**Work Order ID 92352**

Item Name: Replacement Skidtube

D2580-041 ASSEMBLY DETAIL

DRAWING NO. D2580	TITLE 205 SKIDTUBE ASSEMBLY	REV. E	<b>DART AEROSPACE LTD ENGINEERING ORDER</b>	D.E.O. NO. D2580-E-1	SHEET NO. SHEET 1 OF 1	SCALE NTS
DRAWN <i>UP</i>	CHECKED <i>ASS</i>	MFG. APPR. <i>ER</i>	APPROVED <i>[Signature]</i>	DE APPR. <i>[Signature]</i>		
DATE 11.12.13	DATE 11.12.13	DATE 11.12.13	DATE 11.12.13	DATE 11.12.13

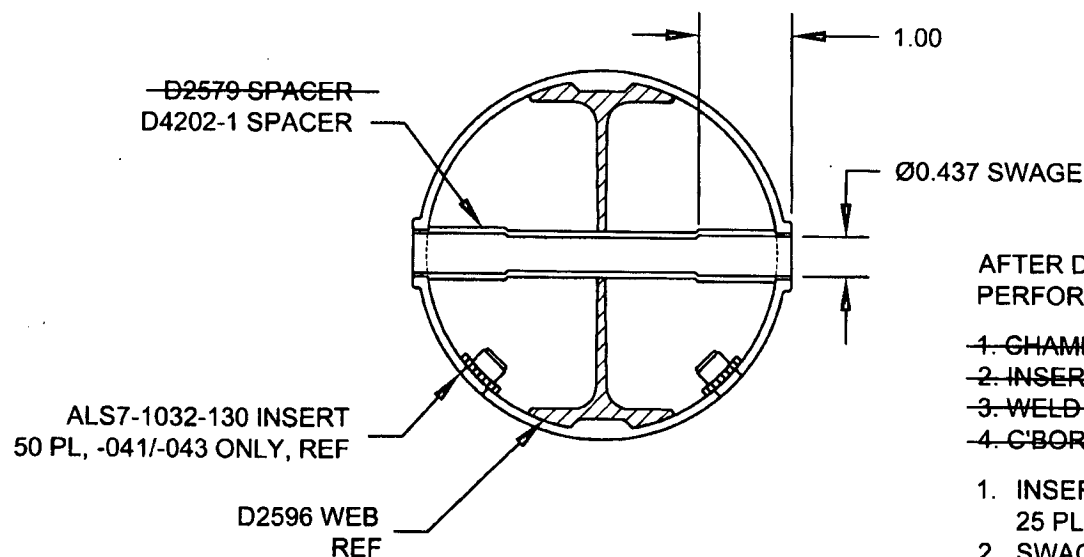
CHANGE ALL C'BORED WELDED CROSSBOLT SPACERS TO SWAGED SPACERS

QTY	QTY	QTY	PART NUMBER	DESCRIPTION
-041	-045	-047		
20	24	25	D2579	CROSS BOLT SPACER

4		* D2579	CROSS BOLT SPACER
20	20	25	D4202-1	SPACER

**\* FOR -045 SKIDTUBE ONLY:**

WELD 4X D2579 SPACERS PER DWG  
IN LOCATIONS MARKED "NO C'BORE".  
REF SHEET 4 OF DWG.
